Title: Anchorage Update and Strap Details

Purpose: Improve tank anchorage design and add anchor strap details/guidance

Source: B. Mistry E-Mail of October 10, 2011 and SGD meeting 11/13/2012 in Los Angeles, CA during discussion of Agenda Item 650-753.

FIGURE 5-28 TYPICAL HOLD DOWN STRAP CONFIGURATION (FOR CARBON STEEL TANK)

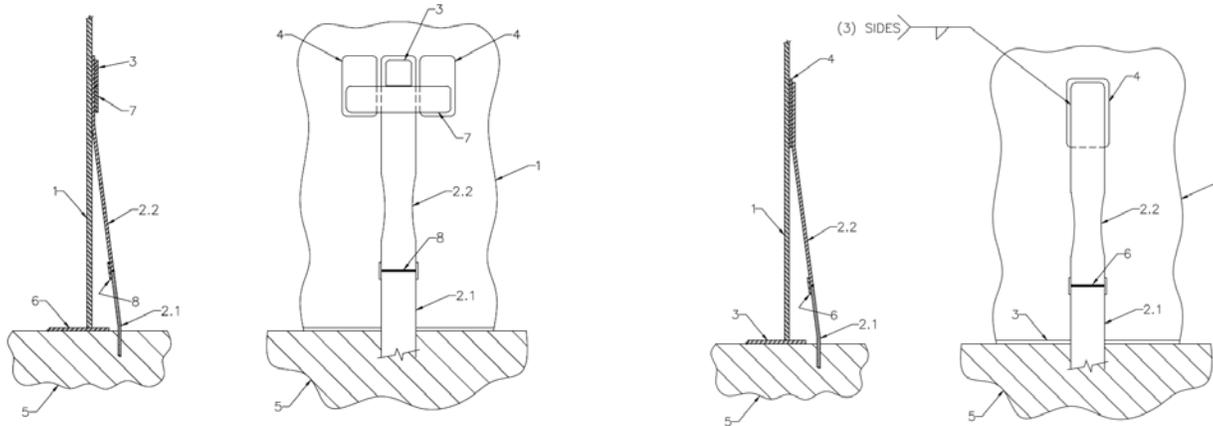
- (6) Insert new Figures 5-28 and 5-29 for anchor straps, and 5-30 for chairs.
- (7) Allow for using bolting materials up to 50,000 psi yield in lieu of limiting to 36,000 psi only as applies for A-36 steel.

5.12.14.2 The design and detailing of the strap should account for corrosion of the strap near the foundation, while not providing too much steel area that reduces the desirable ductile stretching of the strap under overload. One solution is to contour the strap to produce reduced area over a portion of the strap length. See Figures 5-28 and 5-29. A second solution is to specify stainless steel for the hold down strap portion cast in the foundation pour as shown in item 2.1 of Figure 5-28.

- KEY**
- 1) TANK SHELL
 - 2.1) SS HOLD DOWN STRAP
 - 2.2) CS HOLD DOWN STRAP
 - 3) STOPPER PLATE
 - 4) SHELL RE-PADS
 - 5) BASE FOUNDATION
 - 6) TANK FLOOR
 - 7) CROSS PLATE
 - 8) BUTT WELD JOINT (W/ BACKING BAR)

NOTE: PART 2.2 TENSILE AND YIELD PROPERTIES OF THE STRAP MATERIAL TO BE EQUAL TO OR LESS THAN THOSE OF THE SHELL PLATE MATERIAL

Figure 6-30 Typical Anchor Chair

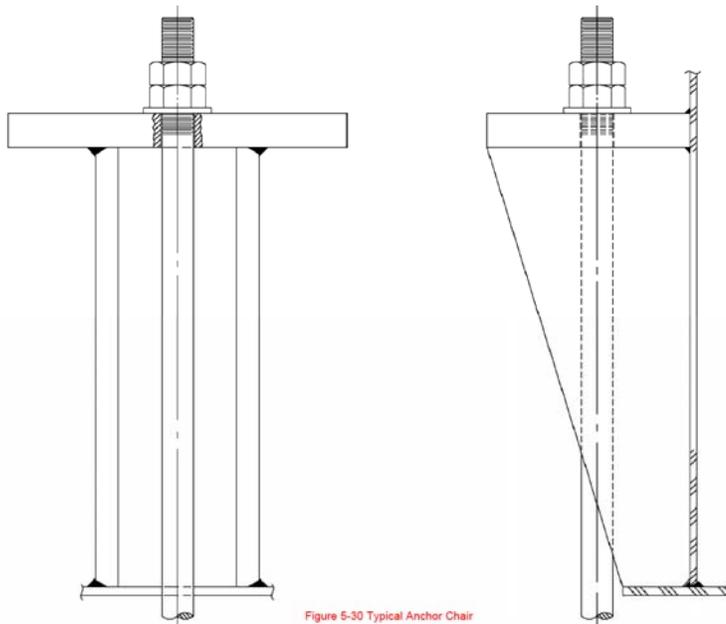
5.12.6 Attachment of the anchor bolts to the shell shall be through stiffened chair-type assemblies or anchor rings of sufficient size and height. An acceptable procedure for anchor chair design is given in AISI Steel Plate Engineering Data, Volume 2, Part 5 "Anchor Bolt Chairs". See Figure 5-30 for typical chair detail. When acceptable to the Purchaser, hold down straps may be used. See Figure 5-28 and 5-29 for typical hold down strap configurations.

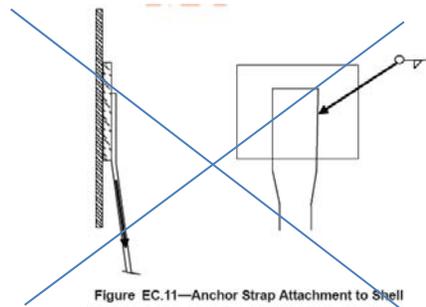
~~Although not the preferred solution for mechanical anchors, straps are permitted. However, if straps are utilized proper details are vital to achieve the performance objective. The anchorage into the foundation should be mechanical, and not rely on bond strength alone. Since there are no direct technical testing methods for validation as exist for anchor bolts, the ability of the detail selected to yield the anchor strap should be demonstrated preferably by test or, at a minimum, by calculation.~~

~~The design and detailing of the strap should also allow for the commonly occurring corrosion of the strap near the foundation, while not providing too much steel area that reduces the desirable ductile stretching of the strap under overload. One solution is to contour the strap to produce reduced area over a portion of the strap length. See figure EC.11.~~

~~The connection to the shell is also often poorly detailed and stresses the attachment weld in the weak direction. Attaching the strap with a single horizontal fillet weld is not recommended. Attaching the strap to a thicker reinforcing plate may also be necessary to avoid over-stressing the shell. One method of detailing a strap is shown in Figure EC.11.~~
